STAFF REPORT

REPORT DATE: January 3, 2019
FILE NUMBER: SUB 2018-08
APPLICANT: Fishbone Construction, LLC, P.O. Box 143, Dayton, OR 97114
OWNER: Tom & Pieper Sweeney, 7175 Wallace Rd., Dayton, OR 97114

REQUEST: Subdivision of approximately 2.68 acres into 17 lots, with 6 lots intended for detached single-family residential development and 11 lots intended for attached single-family residential development, and associated street and utility improvements. Access is proposed from a cul-de-sac westward from Sweeney Street.

PRELIMINARY UTILITY PLAN
SWEENEY PROPERTY SUBDIVISION

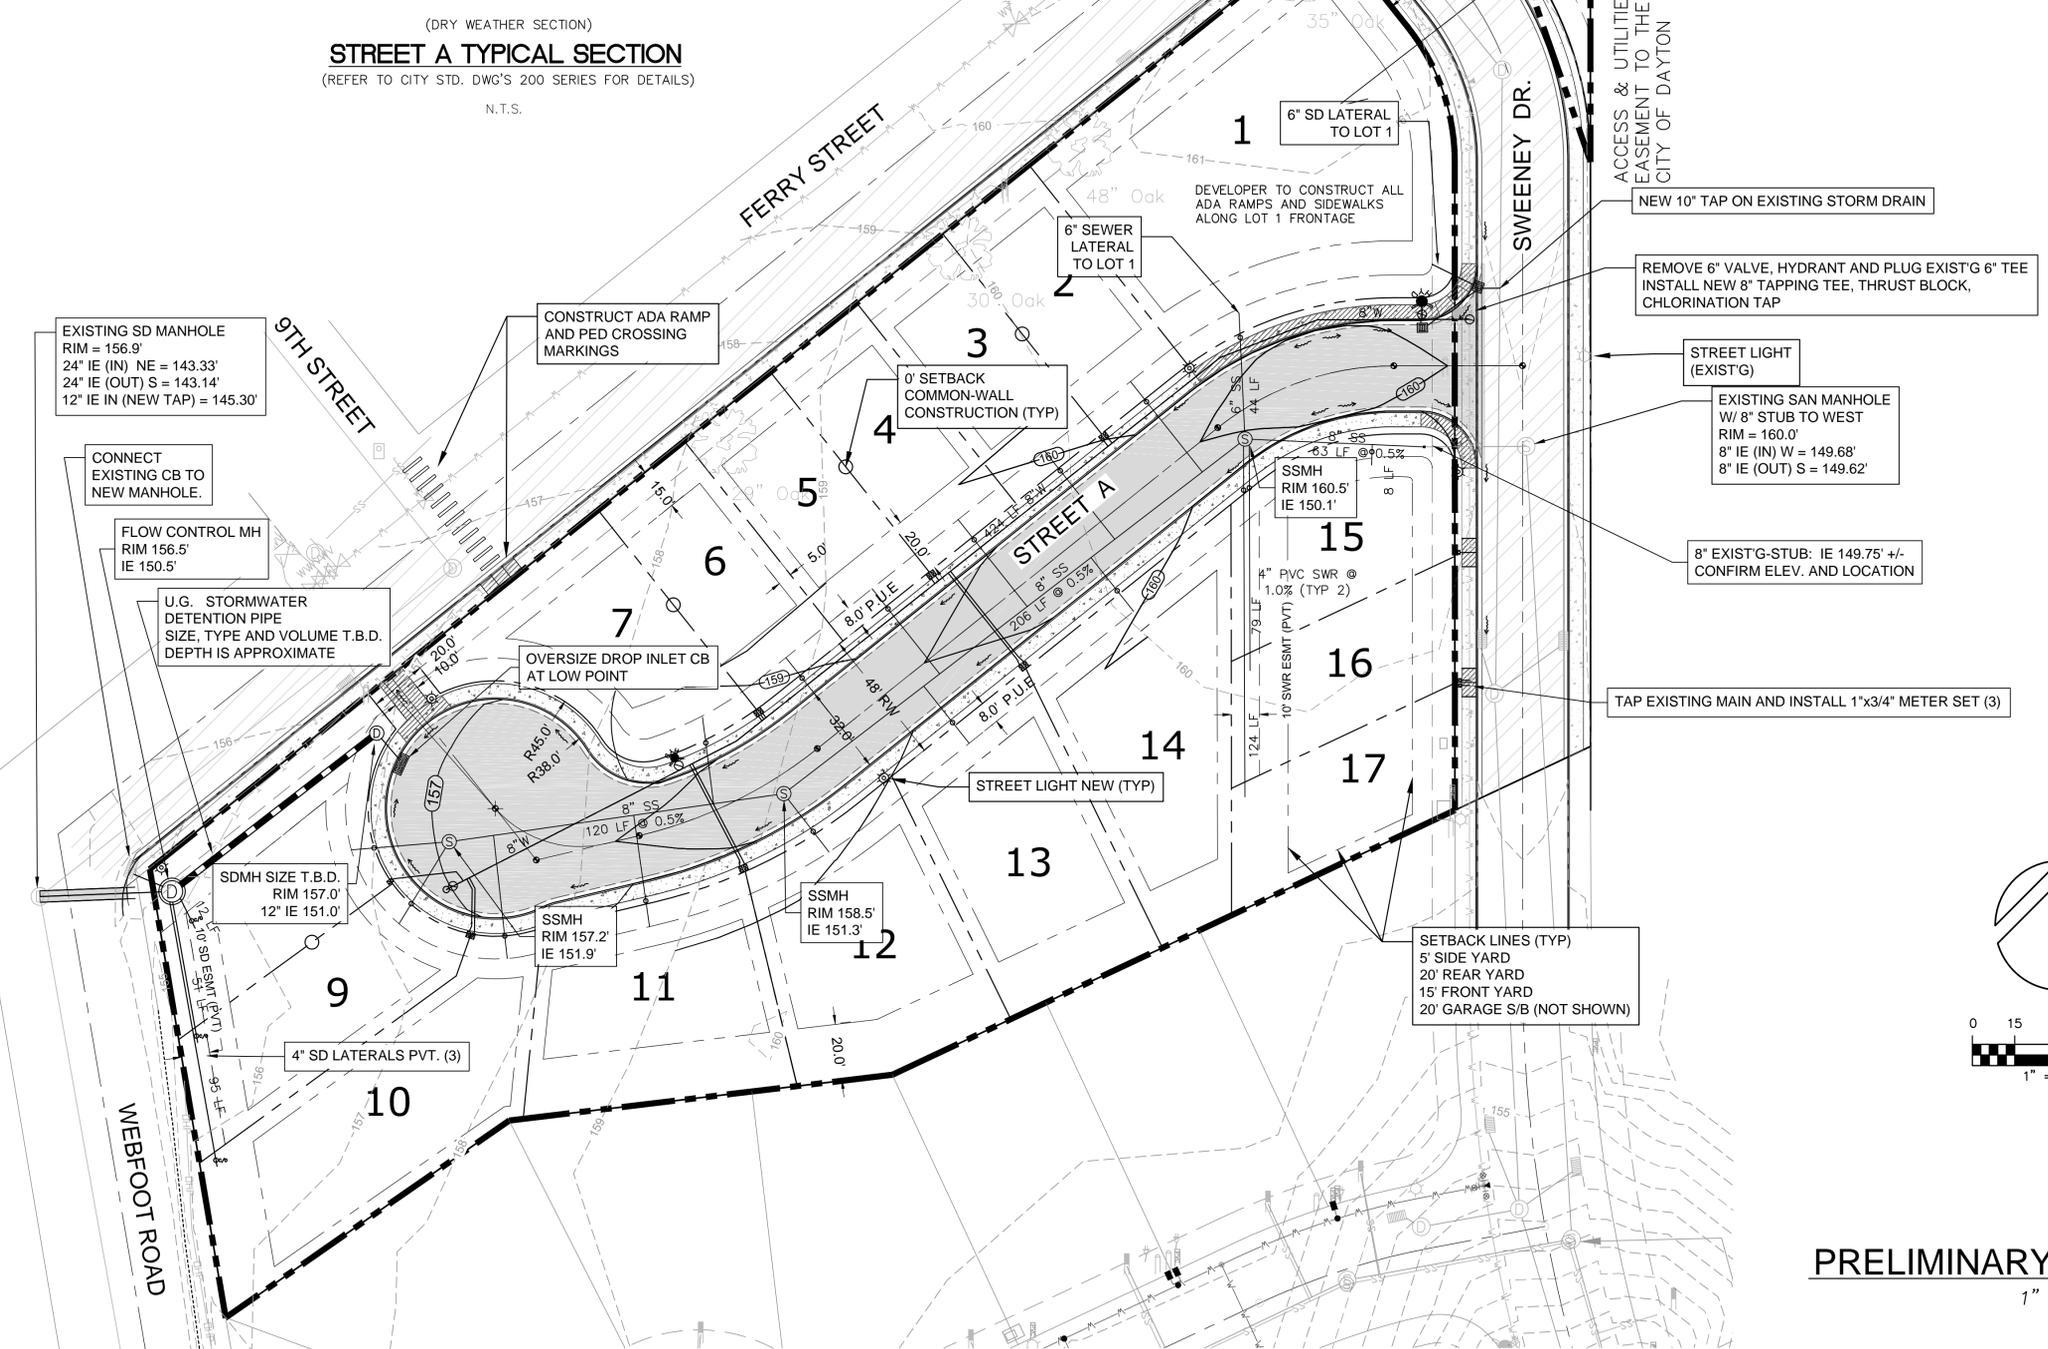
serve this development. This second hydrant is shown on the preliminary utility plan as being located toward the western end of "A" Street and in front of Lot 7.

The preliminary layout drawing included information on proposed lot layout, as well as a proposed grading plan and information on the proposed location of the water & sewer services to serve each of the proposed new lots. This information will be verified in conjunction with the predesign conference and the final subdivision construction drawings.

- The Developer shall submit water system construction drawings conforming to the requirements of the PWDS, and shall demonstrate that the required fire flows are available to all hydrants at the site. All water system improvements required to provide the minimum fire flows (*with or without fire sprinklers*) shall be the sole responsibility of the developer. The developer shall construct new waterlines as required to supply all water services and fire hydrants. Fire hydrants per PWDS standards will be required at intersections and other locations approved by the City Engineer and the Fire Chief. Existing hydrants serving the property shall be provided with Storz adapters per City & Fire District standards, as applicable. Easements per City standards shall be provided by the Developer for any waterlines located outside of public street right-of-ways.
